SERVICE LETTER NO. 70-8

DATE: October 14, 1970

SUBJECT: Rudder Bellcrank Modification

MODELS AFFECTED: AA1-0001 thru 0310, 0312 thru 0332, 0334 thru 0346, 0348 thru 0350, 0352 thru 0375, 0377 thru 0378, 0380 thru 0403, 0405, 0407, 0409, & 0411.

Figure 1. Rudder Bellcrank Modification Procedure.

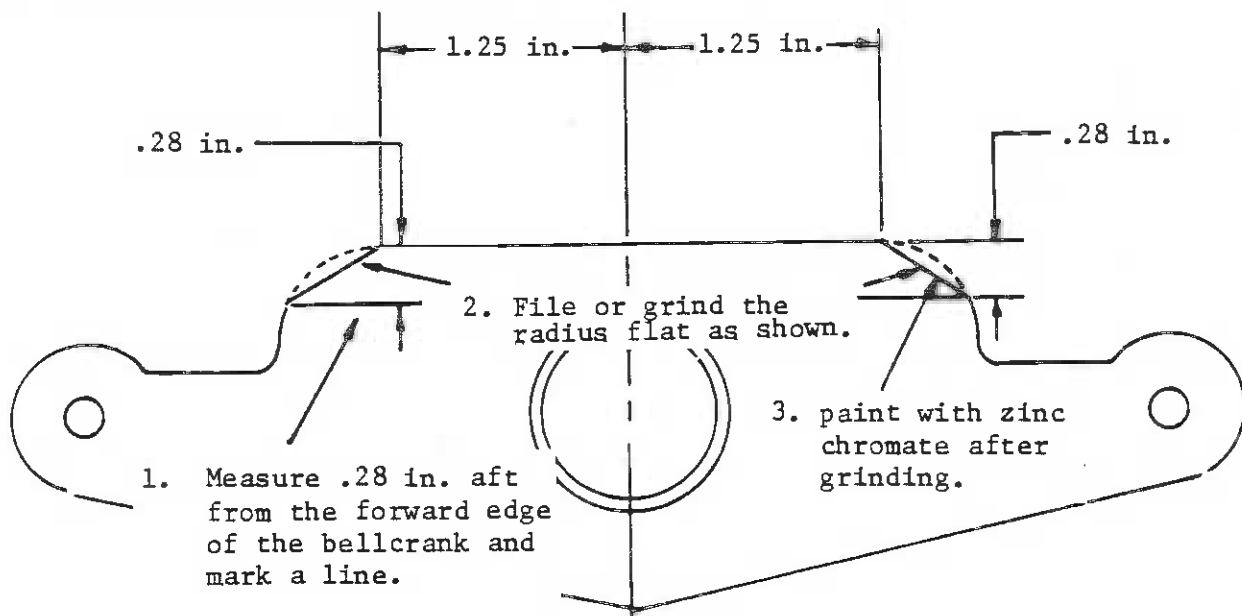
Field reports indicate that on some aircraft a camming action is taking place between the rudder bellcrank and the bellcrank stop bolts due to the radius on the bellcrank at the stop contact point. It is suggested that the bellcrank be modified to provide a flat contact area between bellcrank and stop bolts at the next scheduled inspection, or sooner at the owner's discretion.

3. Rework the rudder bellcrank as shown on figure 1.

Figure 2. Rudder Tip-Fin Clearance.

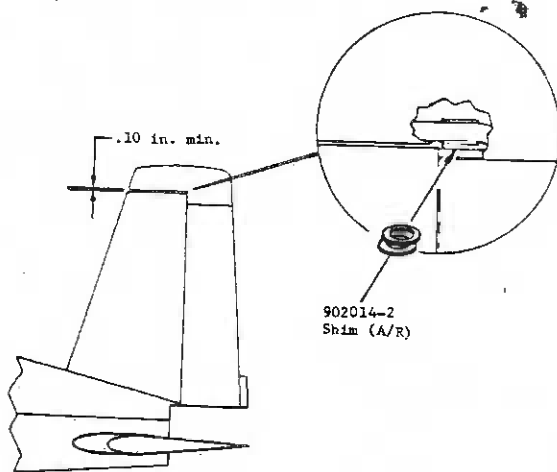
4. Prior to installation of the rudder bellcrank, check the clearance between the rudder tip and fin. Minimum clearance is 0.10 inch as shown on figure 2. If clearance is less than 0.10 inch, install shims part number 902014-2 as required. Lubricate the rudder bearings, as required, with Aeroshell grease #6 or equivalent per MIL-G-7711.

Figure 3. Rudder Bellcrank Stop Bolt Adjustment.

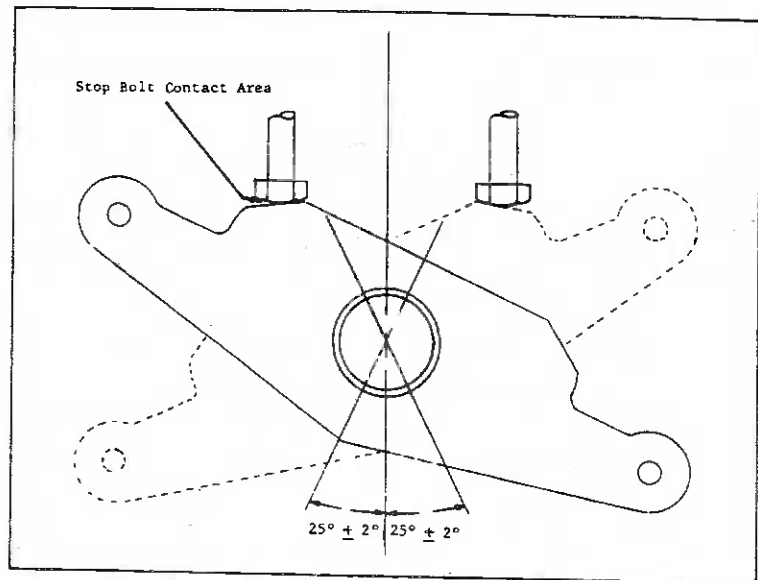
5. Install the rudder bellcrank, REMOVE THE BLOCKS FROM BEHIND THE RUDDER PEDALS and adjust the rudder stop bolts to provide  $25^\circ \pm 2^\circ$  rudder travel, both right and left as shown on figure 3.
6. Install the tail cone assembly and check rudder and rudder pedals for proper travel and operation.
